Monroe County Board of Commissioners Agenda Request Form

**OFFICE OF
MONROE COUNTY PLAN COMMISSION
501 N Morton Street, Suite 224
BLOOMINGTON, IN 47404**

The Trails at Robertson Farms Planned Unit Development Outline Plan

CASE NUMBER	PUO-23-7
PLANNER	Daniel Brown
PETITIONER	Donald Adkins Jr & Kevin Schmidt, C/o Daniel Butler, Bynum Fanyo & Assoc.
OWNER	White Oak Endeavors LLC
REQUEST	Planned Unit Outline Plan
ADDRESS	4691 S Victor Pike, Parcel #: 53-08-20-400-102.000-008
ACRES	42.12 +/-
ZONE	Estate Residential 1
TOWNSHIP	Perry
SECTION	20
PLATS	Unplatted
COMP PLAN DESIGNATION	MCUA Mixed Residential

EXHIBIT 4: New Petitioner Site Plan

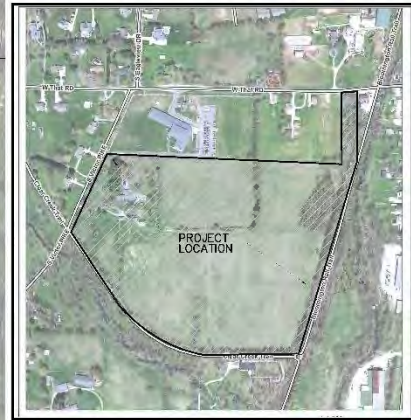
4. Change karst conservancy areas to meet the 50 ft protection requirements per Chapter 761. Relocate/remove proposed dog park illustrated on the southside between lots numbered 96 and 97 on Exhibit 4.

5. Petitioner change the site plan and outline plan to state that the Open Space plan for the northeast side of the property shall protect the delineated floodplain zone and not propose any structures in this area, including eliminating any proposed boardwalks.

4. Change karst conservancy areas to meet the 50 ft protection requirements per Chapter 761. Relocate/remove proposed dog park illustrated on the southside between lots numbered 96 and 97 on Exhibit 4 (*Now described as lots numbered 93 and 94 on the site plan submitted on July 15, 2024*).
